**Safety recommendation: AIC 19-R18/18-1004**

**Addressed to: Jeppesen**

**Investigation link: AIC 18-1004**

**Figure 1: Jeppesen (Chuuk International & Pohnpei International) charts showing the inconsistent terminology used to indicate *Trans level: FL 055* and *Trans level: FL 55*.**

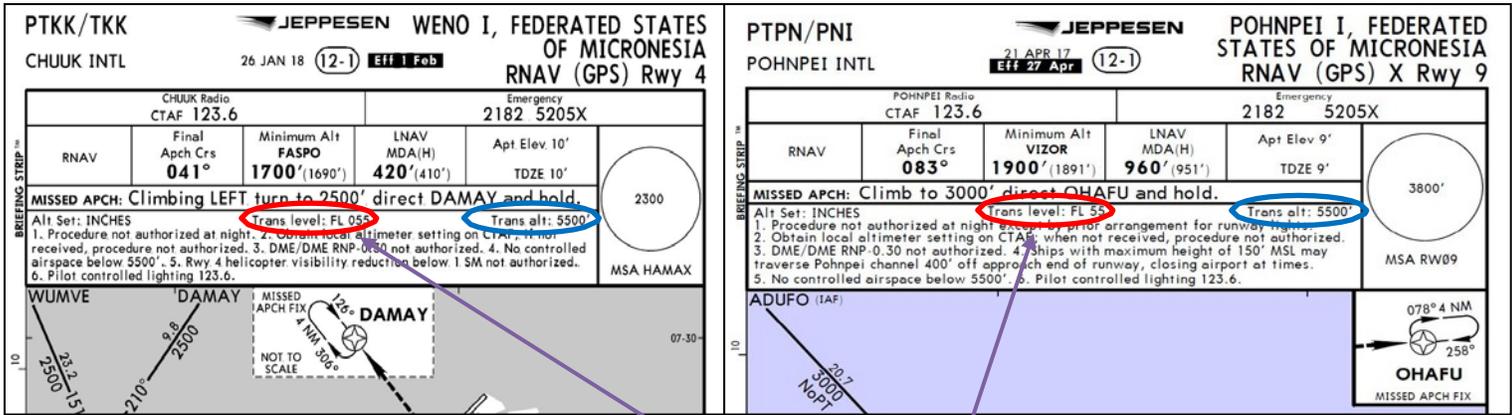
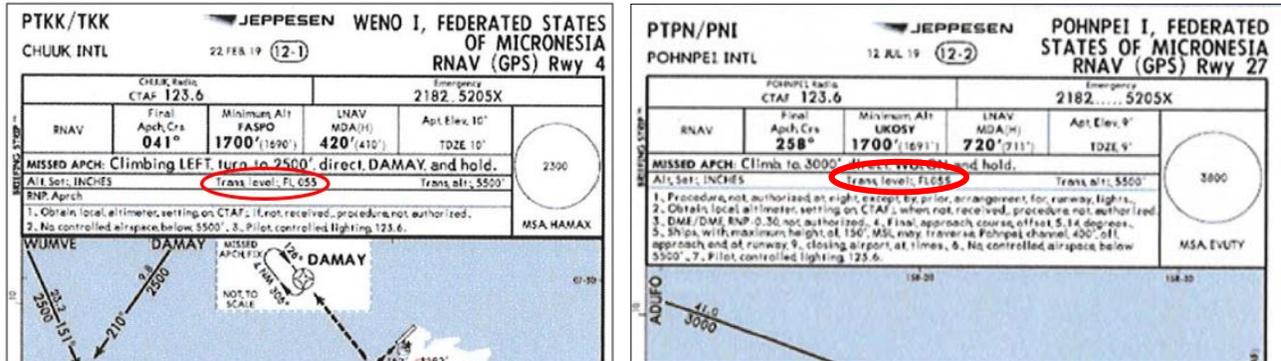
The investigation found that the terminology used to indicate the *Transition Level*<sup>7</sup> on the approach chart as shown in Figure 1 was not consistent.

On the Chuuk RNAV (GPS) Rwy 04 chart, Jeppesen indicates the Transition Level as **Trans: FL 055** and as **Trans: FL 55** on the Pohnpei RNAV (GPS) X Rwy 09 as depicted in Figure 1, although both are referring to the same thing (Trans alt: 5500’, see Figure 1).

Furthermore, the inconsistent use of terminology(s) can bring confusion and risk of comprehension errors when briefing the instrument approach plate, thus inducing the risks of pilot input errors.

The PNG Accident Investigation Commission recommends that Jeppesen should ensure that standard terminology is used on both (Chuuk RNAV (GPS) Rwy 04 and Pohnpei RNAV (GPS) X Rwy 09) instrument approach charts. Jeppesen should also ensure that terminologies and the layout used on all Jeppesen Instrument approach charts are consistent and standardised.

*In reply to Section 4.2.17 Recommendation number AIC 19-R18/18-1004 Jeppesen has updated for consistency the charts for PTPN, PTRO, PTSA airports per the AIC finding so that all transition levels read FL055. The revised charts were released with this correction on 12 July 2019.*

**Figure 2: Jeppesen (Chuuk and Pohnpei Airport) charts showing the amended terminology used to indicate *Trans level: FL 055*. Example of change promulgated on the full suite of charts.**

The AIC has reviewed the Jeppesen documents providing evidence to the AIC of the safety action taken with respect to the listing of transition levels on the full suite of charts for Micronesia airports. The AIC is satisfied that the evidence addressed the safety deficiencies identified in the AIC *Safety Recommendation AIC 19-R18/18-1004*.
